DETAILED ACTION

Figure i- The APA provided by applicant.

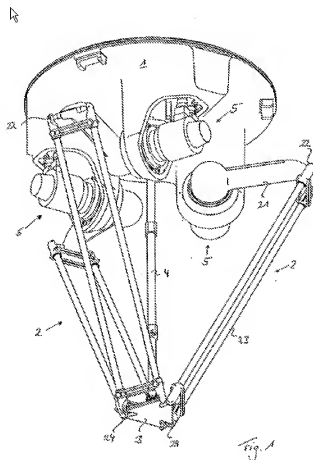
1. Figure 1 should be designated by a legend such as --Prior Art-- because only that which is old is illustrated. See MPEP § 608.02(g). Corrected drawings in compliance with 37 CFR 1.121(d) are required in reply to the Office action to avoid abandonment of the application. The replacement sheet(s) should be labeled "Replacement Sheet" in the page header (as per 37 CFR 1.84(c)) so as not to obstruct any portion of the drawing figures. If the changes are not accepted by the examiner, the applicant will be notified and informed of any required corrective action in the next Office action. The objection to the drawings will not be held in abeyance.
2. The drawings are objected to under 37 CFR 1.83(a). The drawings must show every feature of the invention specified in the claims.

- a base element corresponding to a base element(fig.1, 1) in the APA.
- At least three motor/gearing units disposed on the base element corresponding to the motor/gearing units (fig.1, 5) of the APA.
- A common supporting element on which at least one gripping means for gripping an object is disposed. The supporting

element corresponds to the supporting element (fig.1, 3) of the APA, and the applicant recites a 112th 6th paragraph limitation in regards to the gripping means which is disclosed on page 2, paragraph 24 in the discussion of the APA.

- At least three arms corresponding to arms (fig.1, 2) of the APA. One end is connected to the motor unit and a second end hinge-connected to the common supporting element which is also taught by the APA, fig.1.
- The motor/gearing unit having a gearing with at least one gear step which is tensioned. The APA fails to disclose this.
- The gear step, having a material-locking or positive-locking connection between gearing components, and being free or virtually free from backlash over the whole motional range of the gearing. The APA fails to disclose this as well.

Applicant claims the device with precisely three arms, precisely three motor/gearing units and where the units are positioned on one side each of an imaginary triangle. The APA teaches all this structure in figure 1 along with the proper positioning.

Applicant claims the device where the imaginary triangle is an equilateral. The APA also teaches this as seen in figure 1.

Applicant claims the device comprising a telescopic forth shaft connected to the carrier element. The APA teaches a telescopic forth shaft (fig.1,4) connected to a carrier element (fig.1, 3).

Figure ii- Mochizuki et al.'s figure.

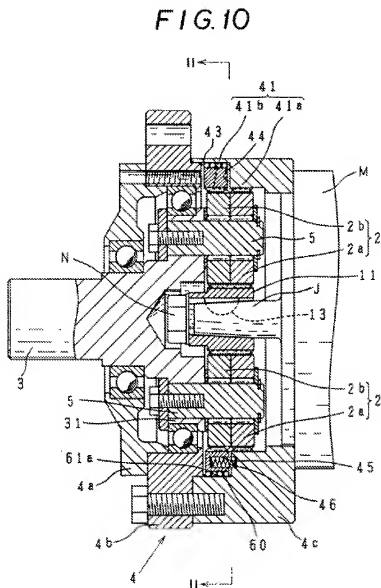
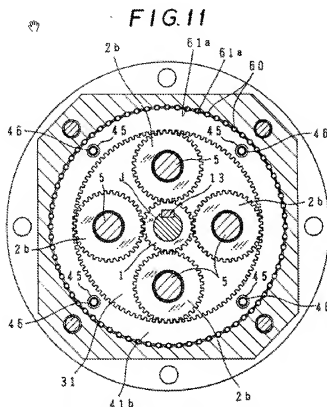
Mochizuki et al. teaches a gearing unit with a gear step which is tensioned via springs (fig. 11, 46). This controls the positioning of the internal gear (col.8, lines 51-59). The gear step has a material-locking connection as seen in figure 11 since the gears are interlocked together. Additionally, the gearing unit is free of backlash as discussed in the abstract and col.9, lines 1-5.

Mochizuki et al. teaches a gear step seen in figure 10 and 11 where the rotation axes of the gears on the drive side and power take off side run coaxially and offset to each other, and Mochizuki et al. teaches a motor M (fig.10, M) coaxially connected to the gear step for the purpose of driving the gearing.

Applicant claims the gearing of the device being a planetary gearing which has planet wheels which mesh between a sun wheel and a ring wheel and which are respectively fixed by a planet wheel bolt to a planet carrier and are mounted rotatably about the respective planet wheel bolt. Mochizuki et al. teaches a planetary gearing unit (fig. 10, 4) which has planet wheels (fig.10, 2), which mesh between sun wheel (fig.10, 11) and internal gear or ring wheel (fig.11, 41b) and the planet wheels are mounted rotatably about the respective bolt seen in figure 10.

Applicant claims the gearing of the device being a planetary gearing, where the gearing has planet wheels which mesh between a sun wheel and ring wheel, with the axes of the planet wheels being arranged offset in comparison to the axis of the sun wheel. Mochizuki et al. teaches all these components as discussed in claims 19-20 and also teaches the axes of the planet wheels being offset with the sun wheel as can be seen in figures 10 and 11.

Applicant claims the gearing of the device as being of single-step or multiple-step configuration. Mochizuki et al. teaches a planetary gearing unit having a multiple-step configuration as can be seen in figure 11. There are multiple step reductions possible using this gear set up.

Applicant claims the device wherein the at least one tensioned gear step is tensioned in a rotationally symmetric manner. Mochizuki et al. teaches this via figure 10 and 11 and col.10 lines 45-47, where as seen the springs are located symmetrically about the gearing unit and therefore tension the gear step in a rotationally symmetric manner.

Figure iv- Altenbokum et al. figure.

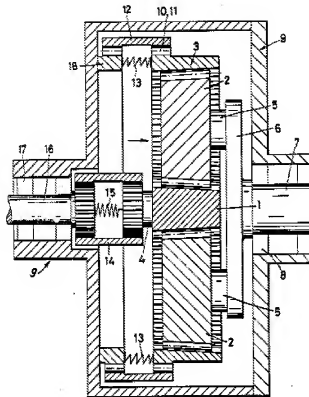
Altenbokum et al. discloses a planetary gearing that has a spur gear combined inside (fig.1, 3) and (col.2, line 16 and line 31). This planetary gear also has a gear step seen in figure 1 wherein the drive side axis running through element 1, is offset to the power take off side axis running through element 5. This planetary gear unit provides a play-free or backlash free planetary drive.
